CITY OF DETROIT
CITY ENGINEERING DIVISION (E.M.D.)
FOR WATER AND SEWERAGE DEPARTMENT

PROPOSED CHANGE ORDER "K" NO. 10
COPLAND SERVICE DRIVE FROM LEIGH ST. TO DEARBORN AVE.
PAVING, DRAINAGE AND DRAINAGE STRUCTURES

PROPOSED CHANGE ORDER NO. 10
COPLAND SERVICE DRIVE FROM LEIGH ST TO DEARBORN AVE.
PAVING, DRAINAGE AND DRAINAGE STRUCTURES

DATE 8-5-76		DRAWING NO. 7400303D		CONTRACT NO. PC 406A		SHEET 1 OF 3 SHEETS	
INDEX NO. 49-50		TOP NO. 1		CONTRACT NO. PC 406A		SHEET 1 OF 3 SHEETS	
INDEX NO. 49-50		TOP NO. 1		CONTRACT NO. PC 406A		SHEET 1 OF 3 SHEETS

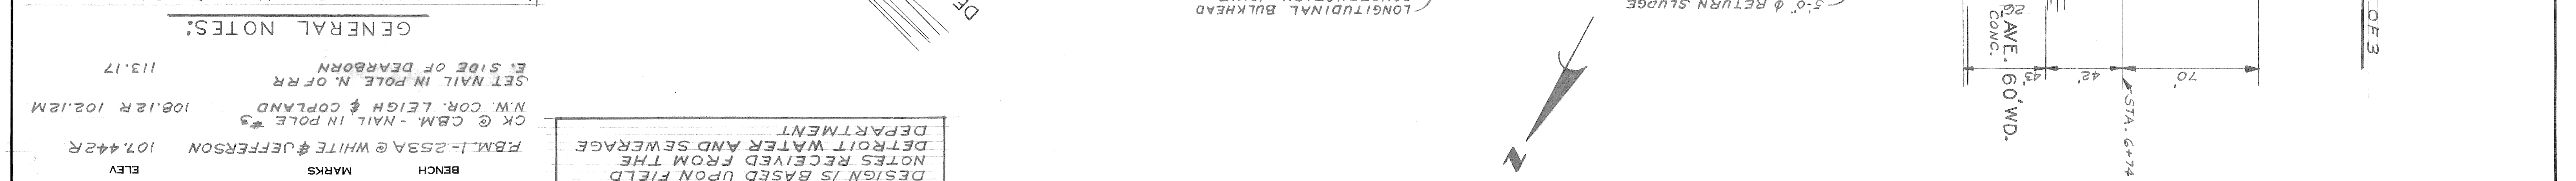
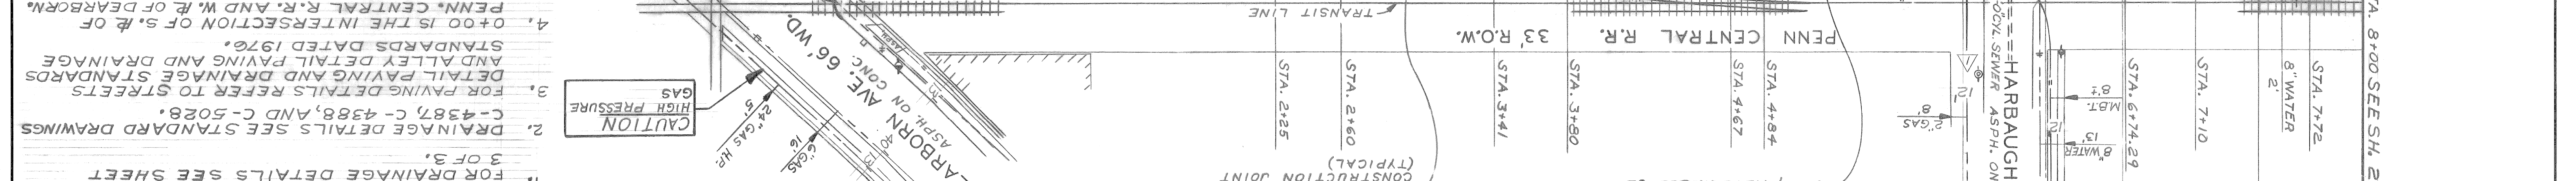
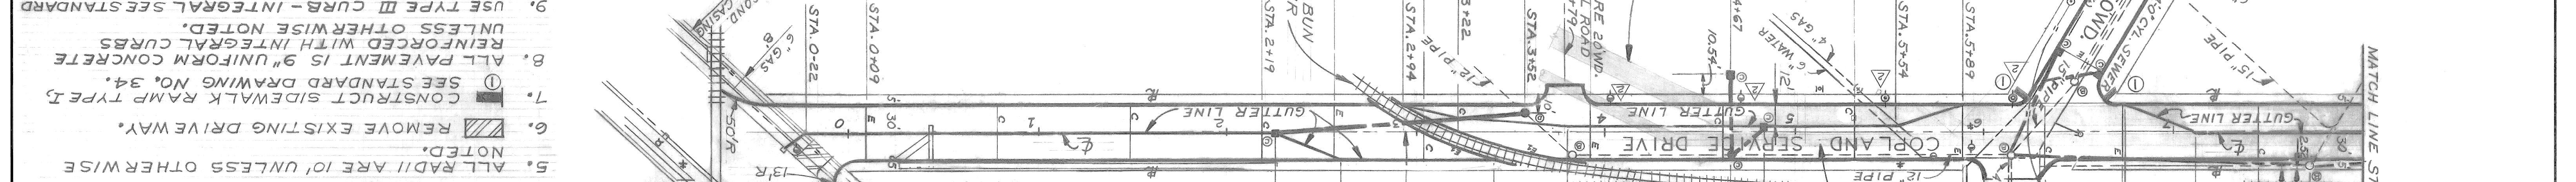
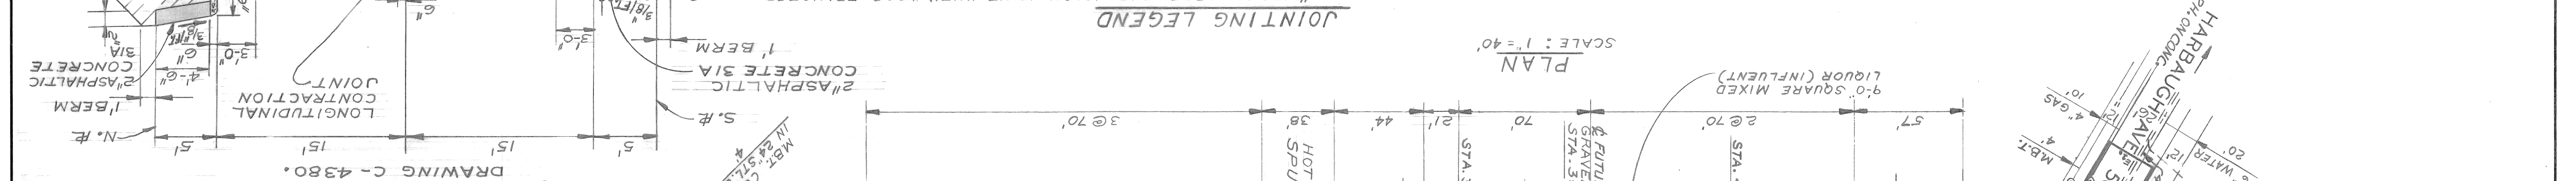
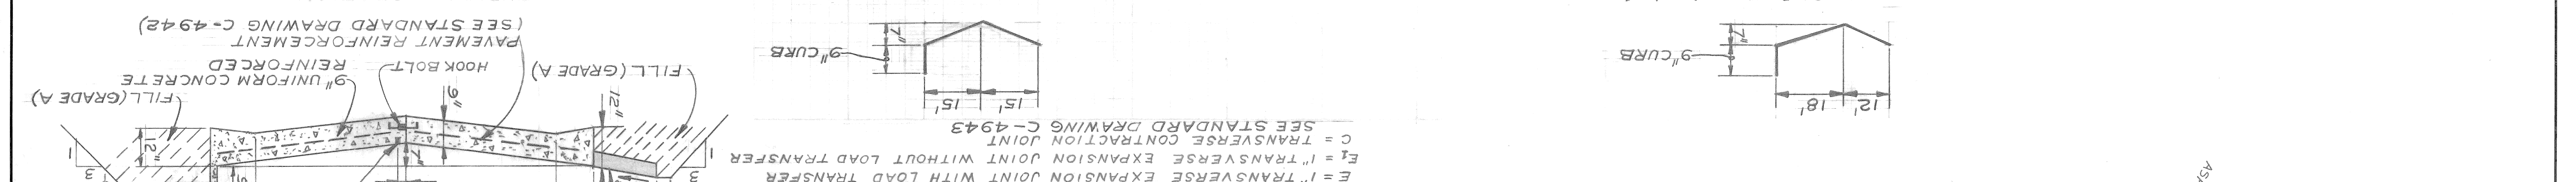
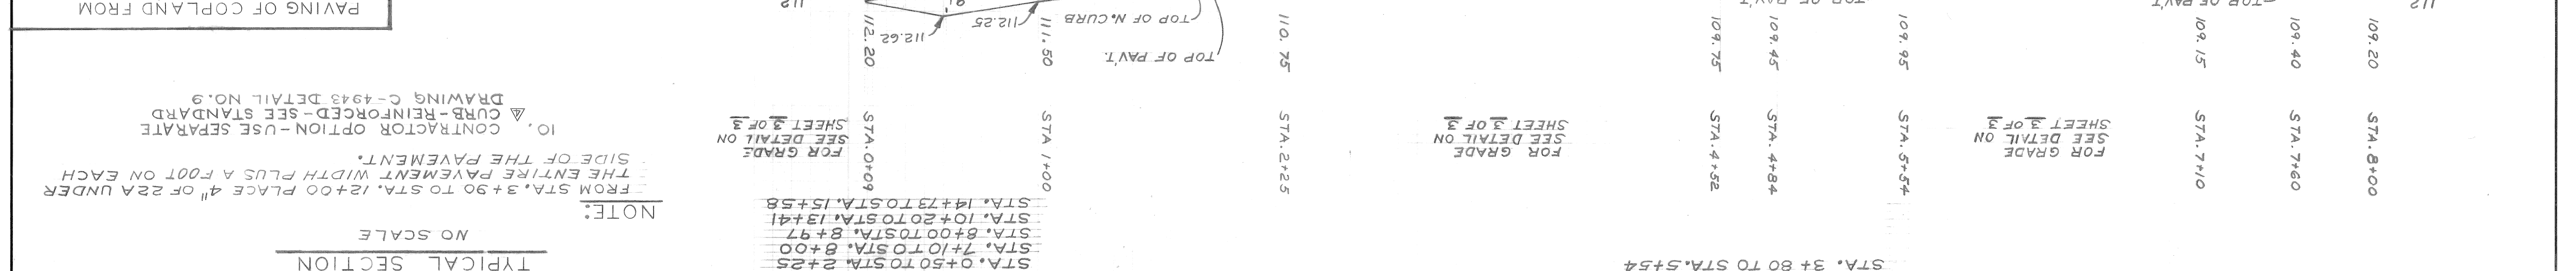
NO.	DATE	DESCRIPTION
1	8-5-76	ADDED GAS LINE HARBAGH N. OF COPLAND
2	8-5-76	ADDED NOTE NO. 10
3	8-5-76	CHANGED TITLE FROM C.O."K" TO C.O."10"
4	8-5-76	CHANGED EDISON SYM. TO R.D. SYM. ON HARBAGH
5	8-5-76	AND ADDED R.D., M.B.T. & EDISON SYM. ON COPLAND

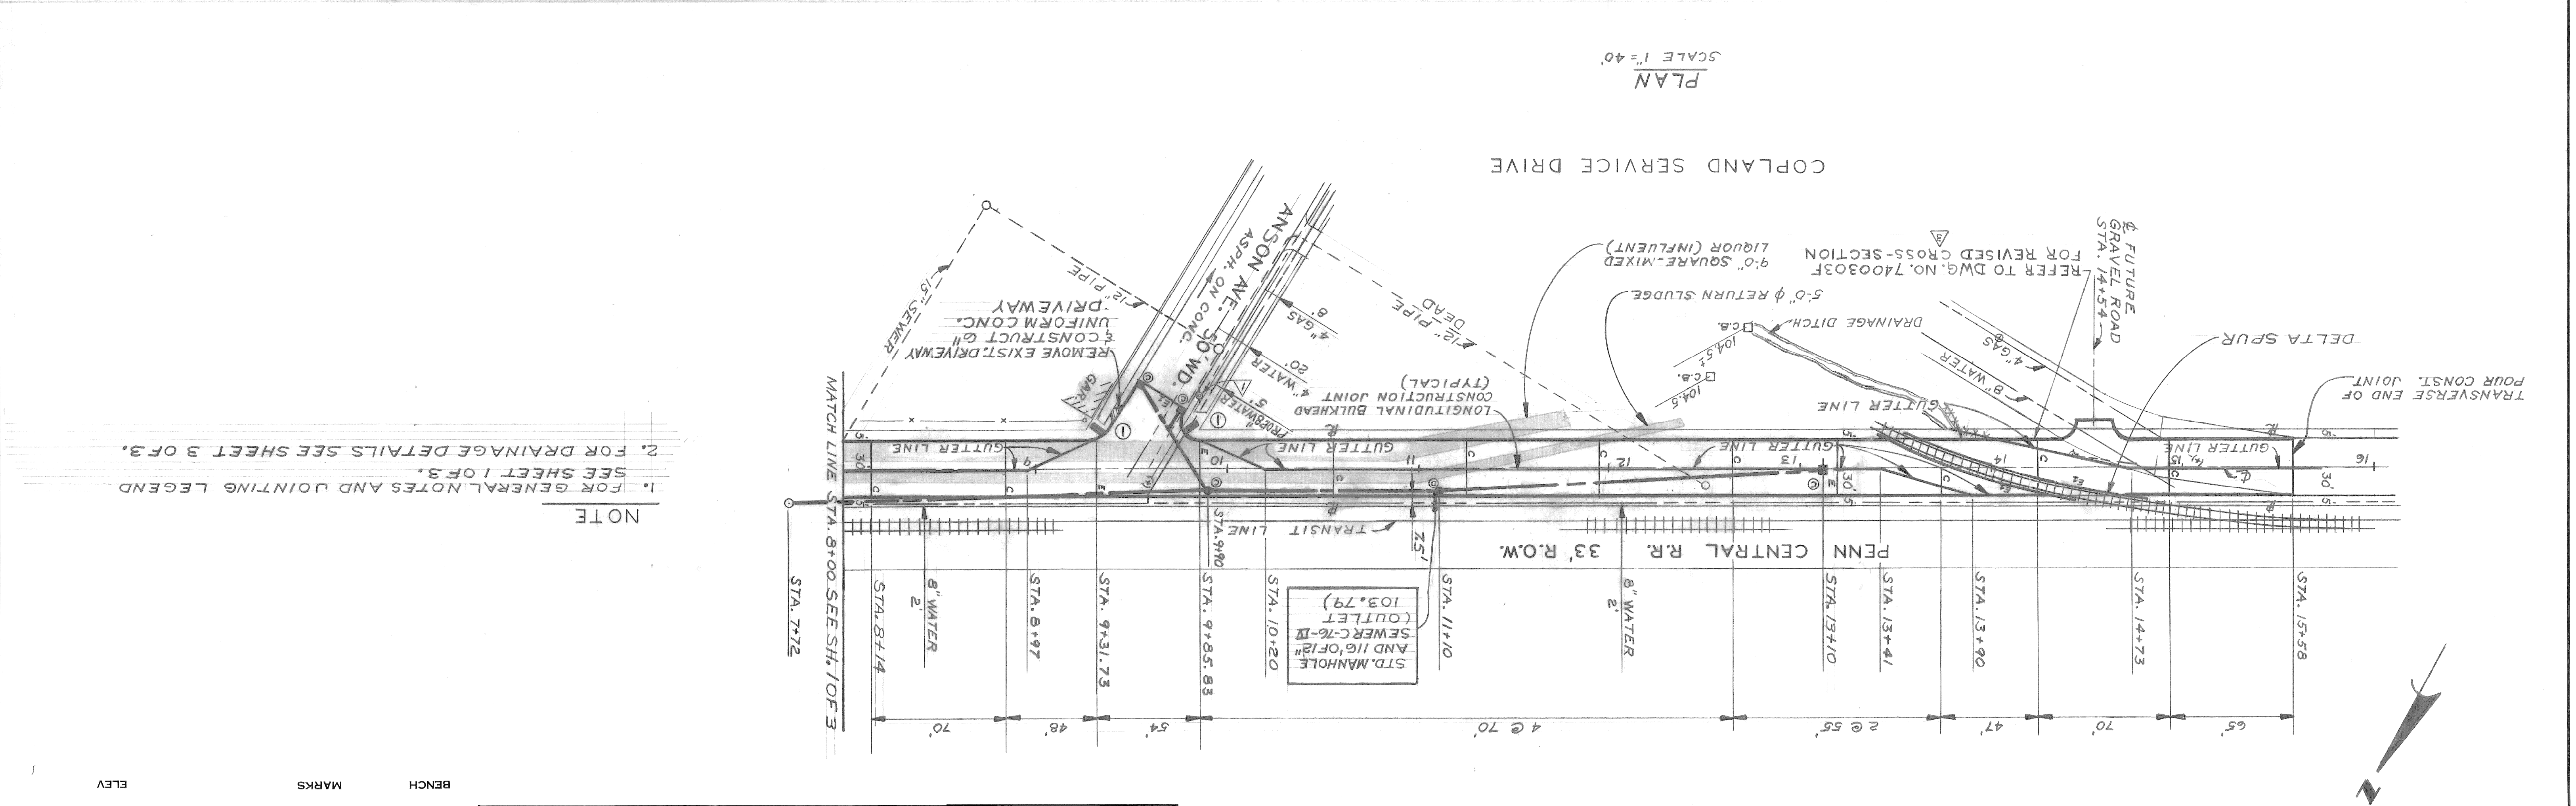
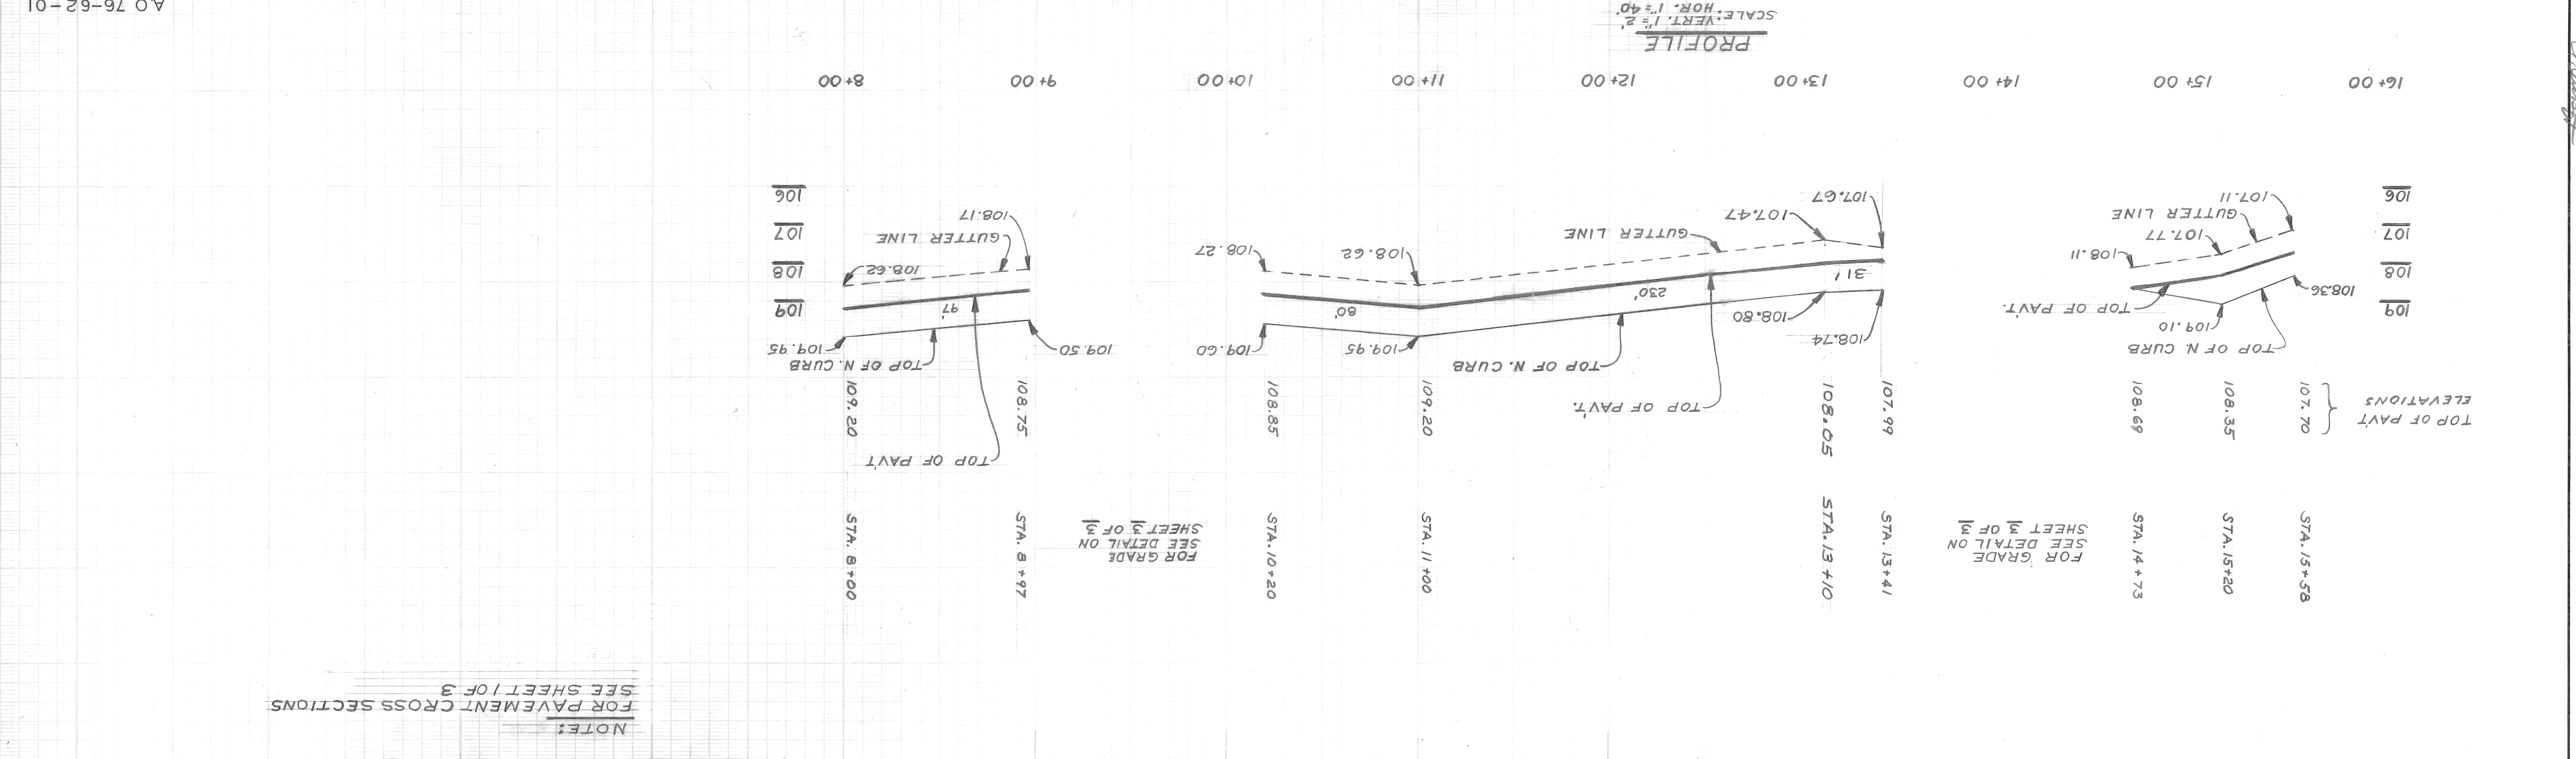
REVISIONS CHANGED EDISON POLE SYM. TO P.D. SYM. ON ANSON CHANGED TITLE FROM C.O.K. TO C.O. "10" ADDED NOTE		PLAN R. Rosik	GRADE ESTIMATE	CHECKED BY APPROVED BY ENGINEER OF STREETS	CITY OF DETROIT CITY ENGINEERING DIVISION (E.M.D.) FOR WATER AND SEWERAGE DEPARTMENT	PROPOSED CHANGE ORDER "K" NO. 10 COPLAND SERVICE DRIVE FROM LEIGH ST TO DEARBORN AVE. PAVING, DRAINAGE, AND DRAINAGE STRUCTURES	INDEX NO. SHEET 2 OF 3 SHEETS CONTRACT NO. PC 406A DRAWING NO. 7400303E DATE 8-5-76
---	--	------------------	-------------------	--	---	---	---

DATE	DRWG NO.	CONTRACT NO.	SHEET NO.
8-5-76	7400303F	PC 406A	3 OF 3 SHEETS

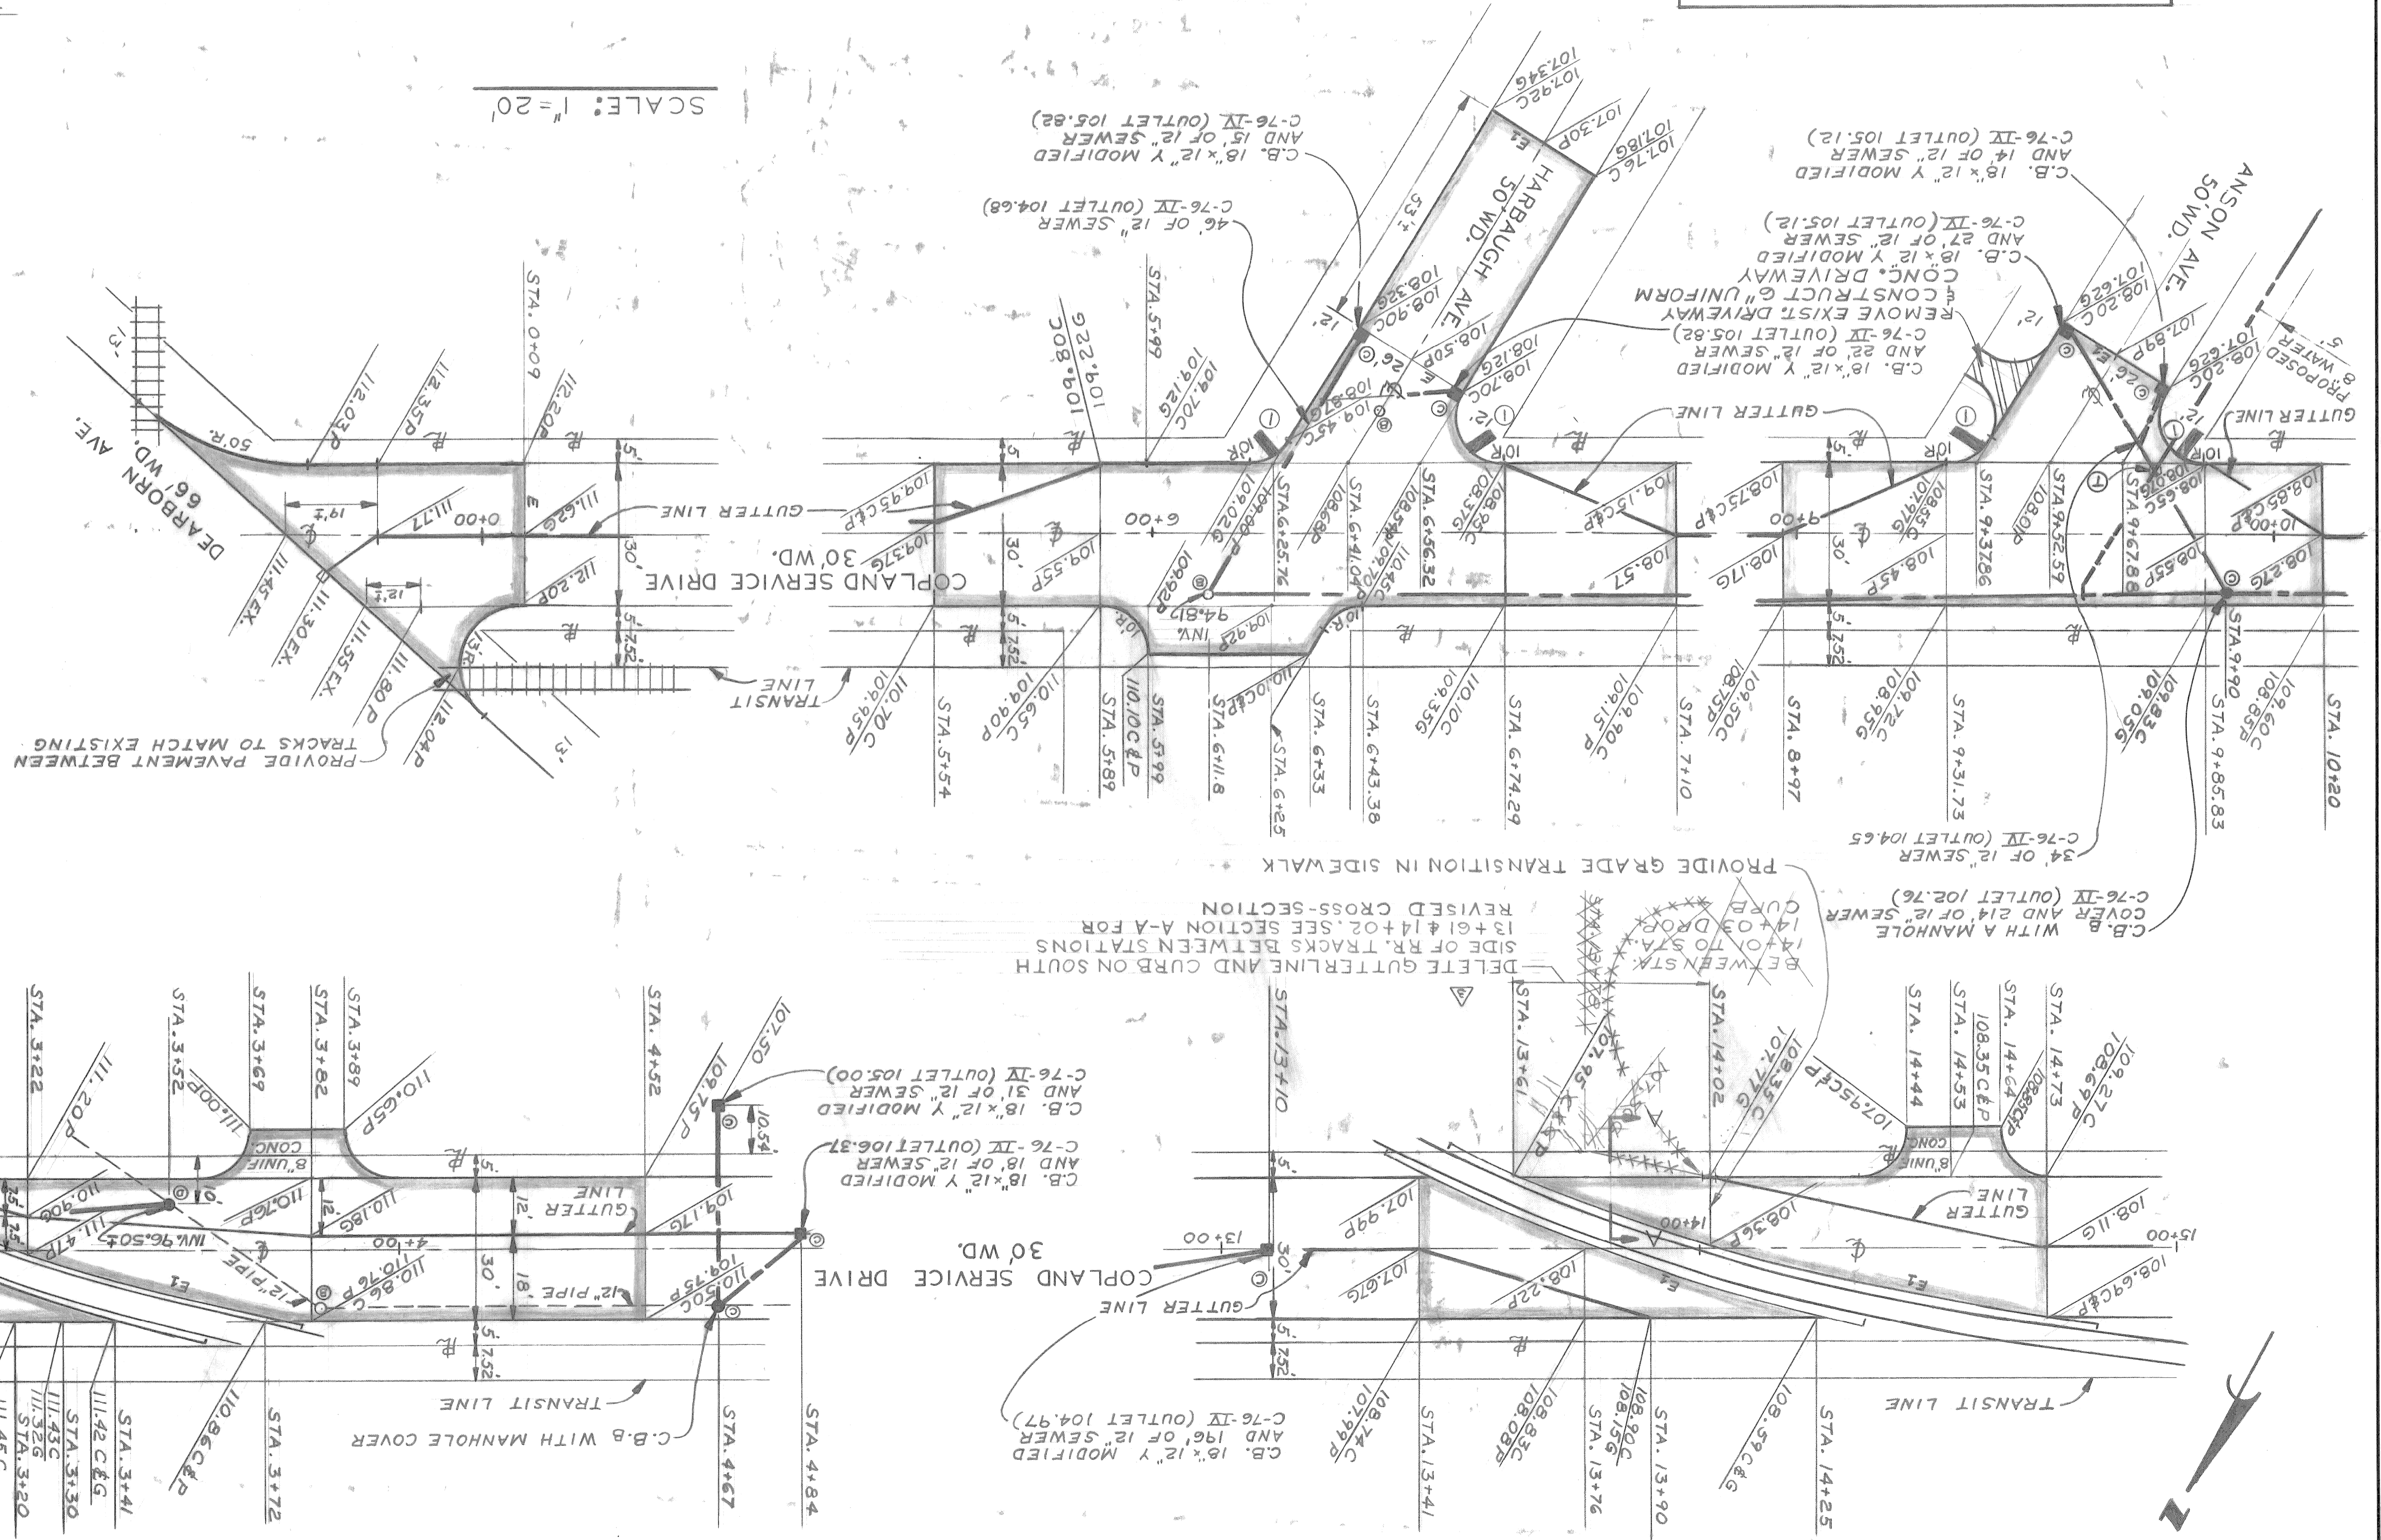
NO.	DATE	DESCRIPTION
1	7/20/16	Added 1' of road elevation
2	7/20/16	CHANGED TITLE FROM C.O.R. TO C.O.P.
3	7/20/16	CHANGED PAVEMENT DETAILS & SECTION
4	7/20/16	CHANGED TITLE FROM C.O.R. TO C.O.P.
5	7/20/16	CHANGED TITLE FROM C.O.R. TO C.O.P.
6	7/20/16	CHANGED TITLE FROM C.O.R. TO C.O.P.
7	7/20/16	CHANGED TITLE FROM C.O.R. TO C.O.P.
8	7/20/16	CHANGED TITLE FROM C.O.R. TO C.O.P.
9	7/20/16	CHANGED TITLE FROM C.O.R. TO C.O.P.
10	7/20/16	CHANGED TITLE FROM C.O.R. TO C.O.P.
11	7/20/16	CHANGED TITLE FROM C.O.R. TO C.O.P.

① = WHERE 12" SEWER LINE CROSSES OVER THE PROPOSED 8" WATER LINE, ENCASE THE 12" SEWER LINE WITH CLASS A CONCRETE FOR A DISTANCE OF 3' ON EACH SIDE OF THE 8" WATER LINE FOR A TOTAL OF 6'.
